Technical Service Bulletin

Topic	DTC P04F000 EVAP system high pressure purge line performance DTC logged
Market area	China 723 Volkswagen (Anhui) Automotive CO (6723),China 796 VW Import Comp. Ltd (Vico), Beijing (6796),Korea, (South) E08 Bentley South Korea (6E08),United States E05 Bentley USA and rest America (6E05)
Brand	Bentley
Transaction No.	2058573/5
Level	EH
Status	Released for publishing
Release date	Feb 21, 2025

Bentayga Kovomo 4.0 TSI

Figure 2

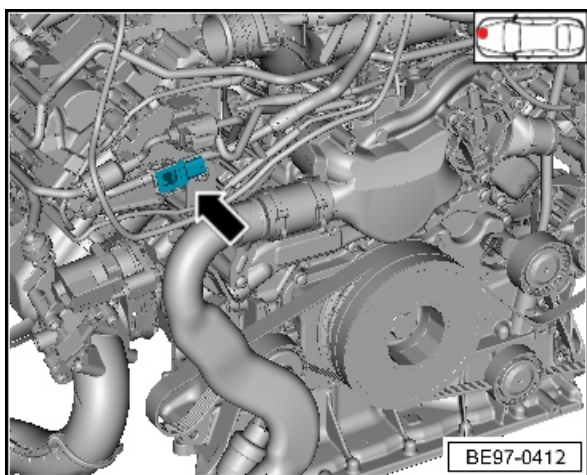
The DTC is related to mismatched terminal locations of the Pressure sensor for the activated charcoal filter system – G804 (Figure 2)

Figure 3

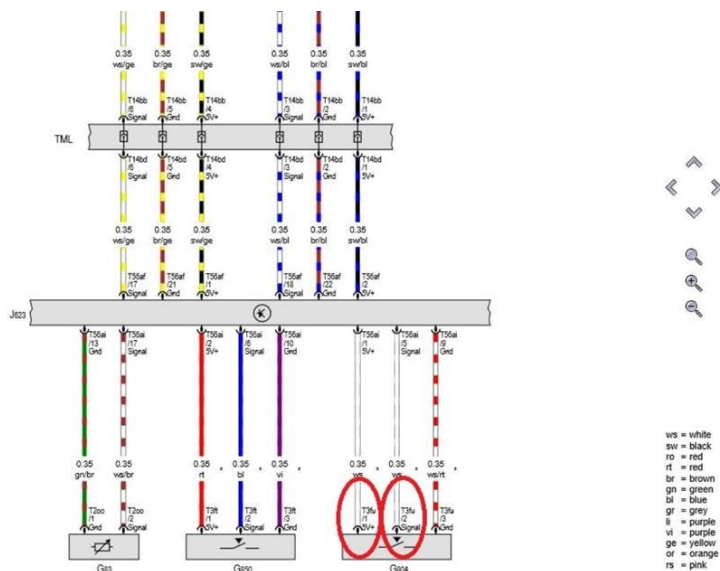
1) Refer to Wiring diagram 106/18 within Elsa pro (Figure 3)

2) Should the terminal locations **NOT** be as shown in Figure 3, the terminals should be reallocated within plug as per the wiring diagram

- Refer to Repair manual Rep.Gr 20 - Tank ventilation pressure sensors - To remove and fit to gain access to the sensor connection
- Reallocate the sensor terminals as per Elsa pro wiring diagram instruction
